Process Sheet

Customer : CC-DAR01 Dart Aerospace Ltd.

Drawing Name : D135-751-011 REWORK

Drawing Number : ECN1036

D3507-1 DRILLING DETAIL

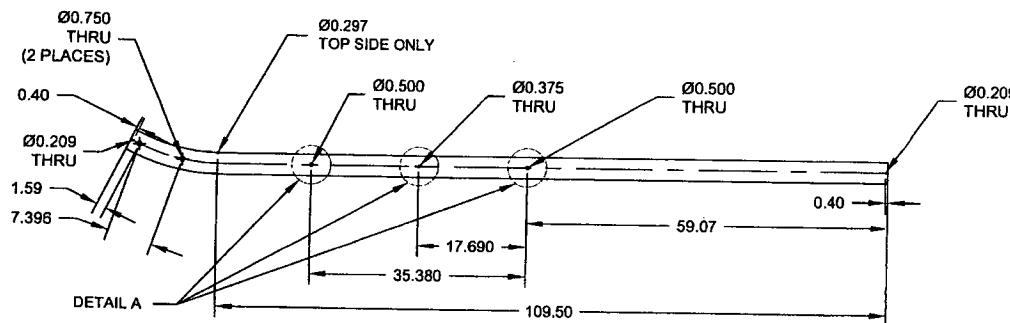
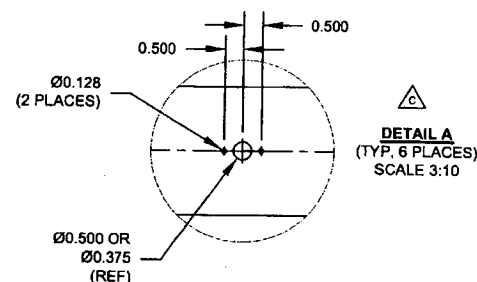
REWORK SKID PER DRWG IAW D3507 REV.C

(DRILLING DETAIL HAS CHANGED)

WELD 2 X D3504-5 CROSSBOLT SPACERS
PER DRWG D3507 REV.C

C	ADD D3504-5, FOR SKID GEAR DEFLECTOR; CHANGE FWD CAP BOLT TO AN526C1032-10 SCREW	DC	07.09.19
B	ADD GASKET, CHANGE HARDWARE MAT'L	PH	06.11.01
A	NEW ISSUE	PH	06.04.21
REV.	DESCRIPTION	BY	DATE
DESIGN	PH	DART AEROSPACE USA, INC PORT HADLOCK, WA	
DRAWN	JTC		
CHECKED	PH		
MFG. APPR.	GP		
APPROVED	JP		
DE APPR.	JP	DRAWING NO. D3507 REV. C SHEET 1 OF 2 TITLE SCALE EC 135 SKIDTUBE NTS	
DATE	07.09.19	COPYRIGHT © 2008 BY DART AEROSPACE USA, INC THIS DOCUMENT IS PRIVATE AND CONFIDENTIAL AND IS SUPPLIED ON THE EXPRESS CONDITION THAT IT IS NOT TO BE USED FOR ANY PURPOSE OR COMED OR COMMUNICATED TO ANY OTHER PERSON WITHOUT WRITTEN PERMISSION FROM DART AEROSPACE USA, INC.

FIGURE 2 - D135-751-011 SKIDTUBE INSTALLATION

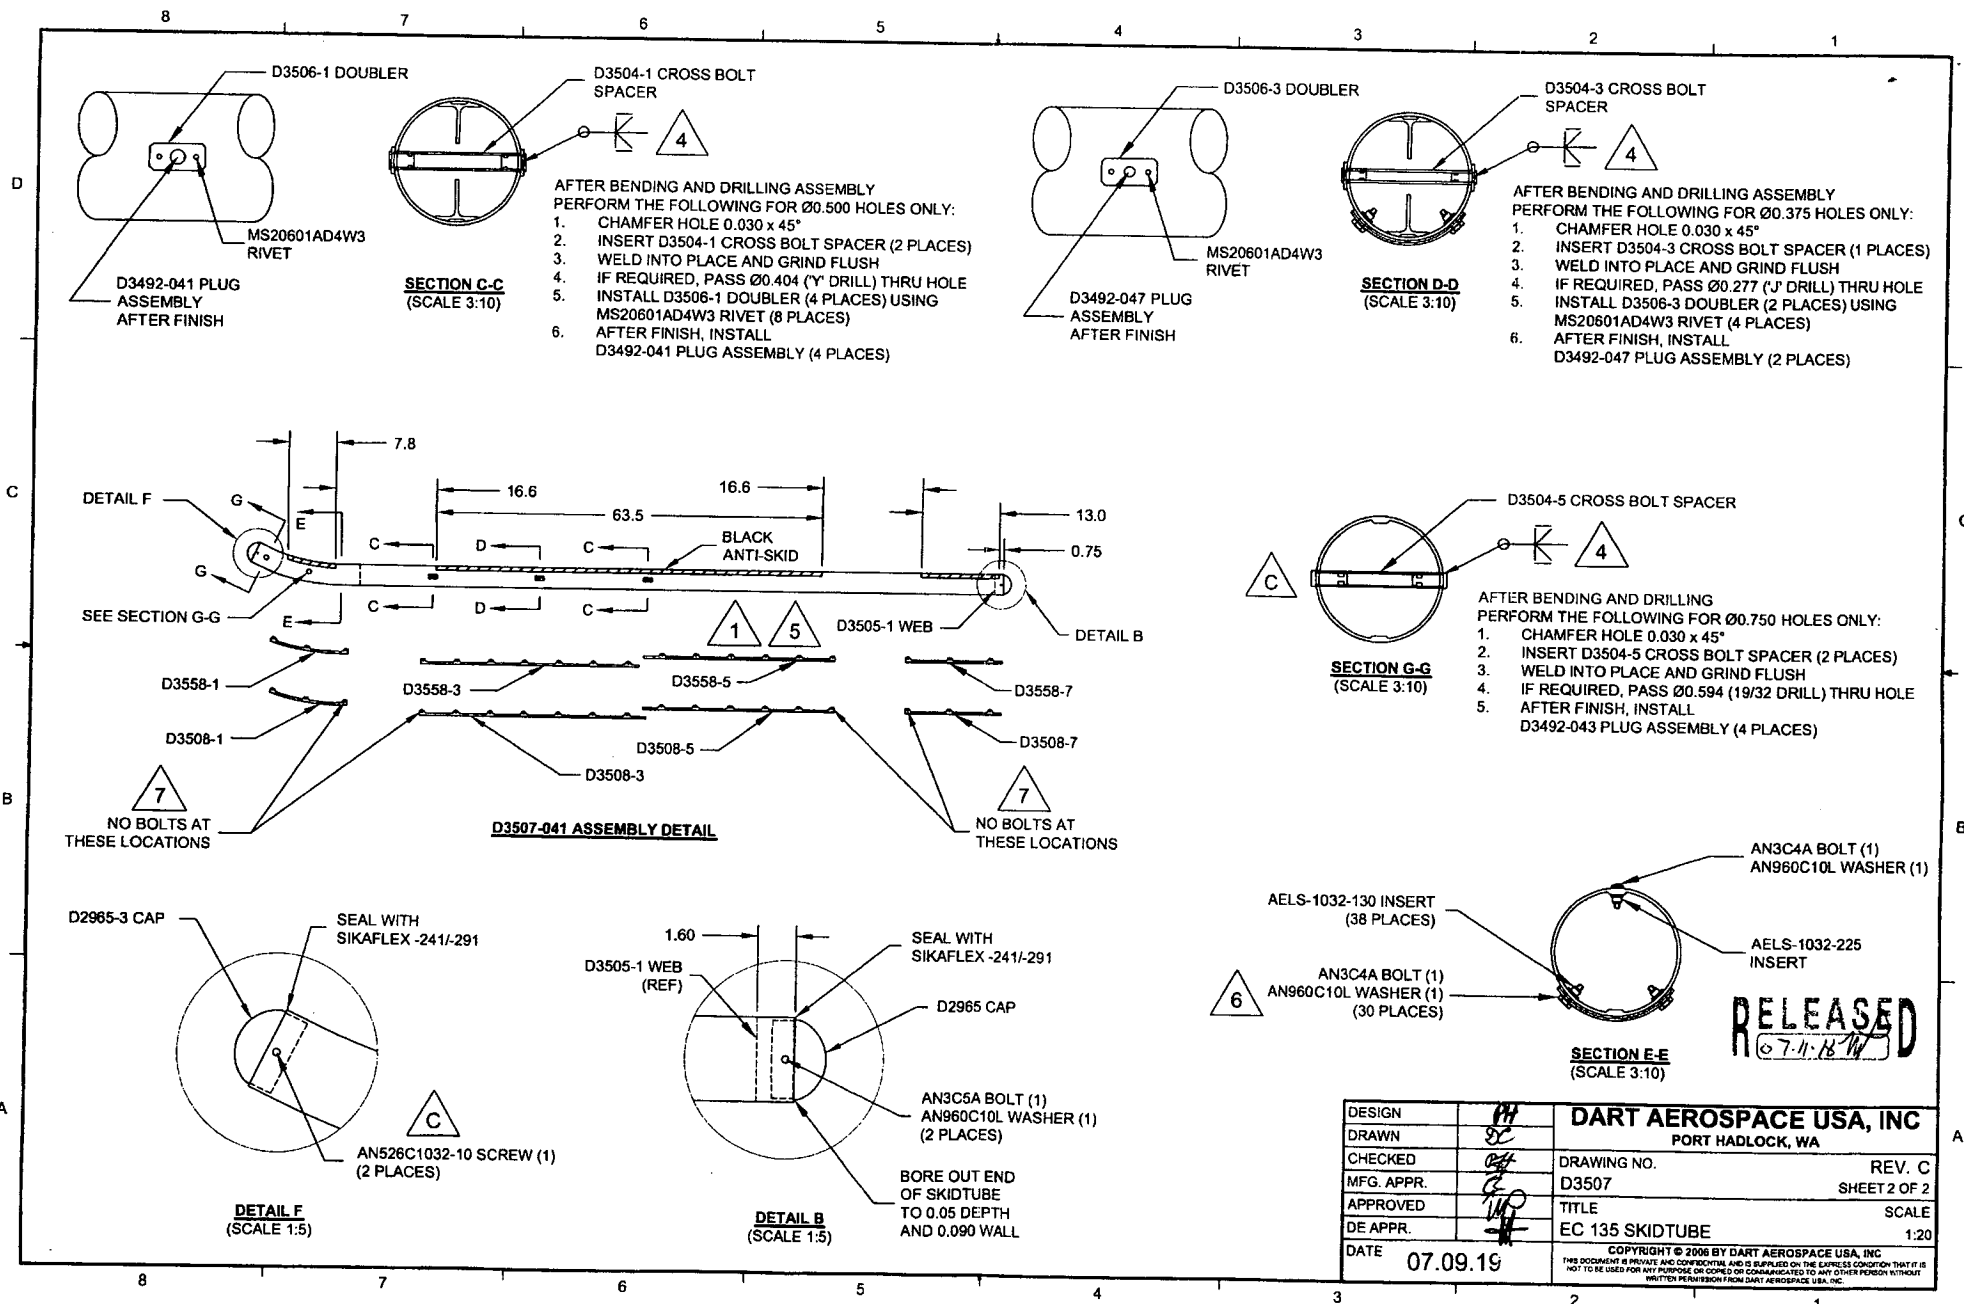
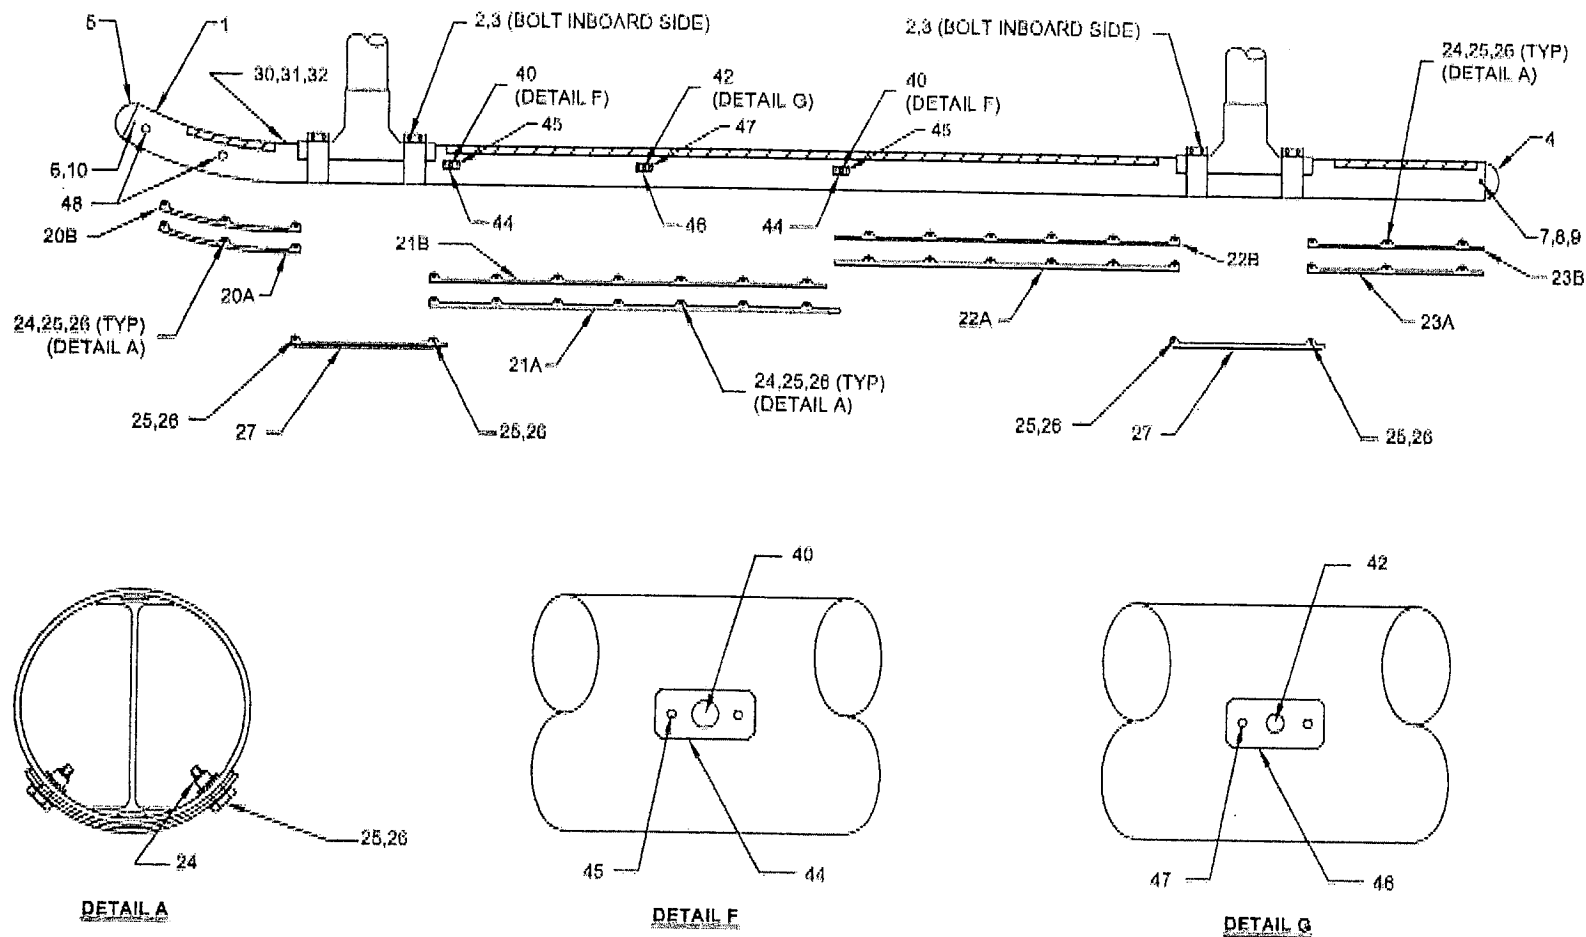
REMOVE 1 X D3508-7 REV.B WEARPLATE

REMOVE 2 X D3512-1 REV.B WEARPLATE

RE-ASSEMBLE CAPS (SIKAFLEX) B M105585 EXPIRE DATE 08-07
& WEARPLATES
PER DRWG D3507 REV.C

PICK NEW 1 X D3508-7 REV.C B 36179
INSTALL PER DRWG D3507 REV.C

PICK 4 X D3492-043 PLUGS B 35840
INSTALL PER DRWG D3507 REV.C
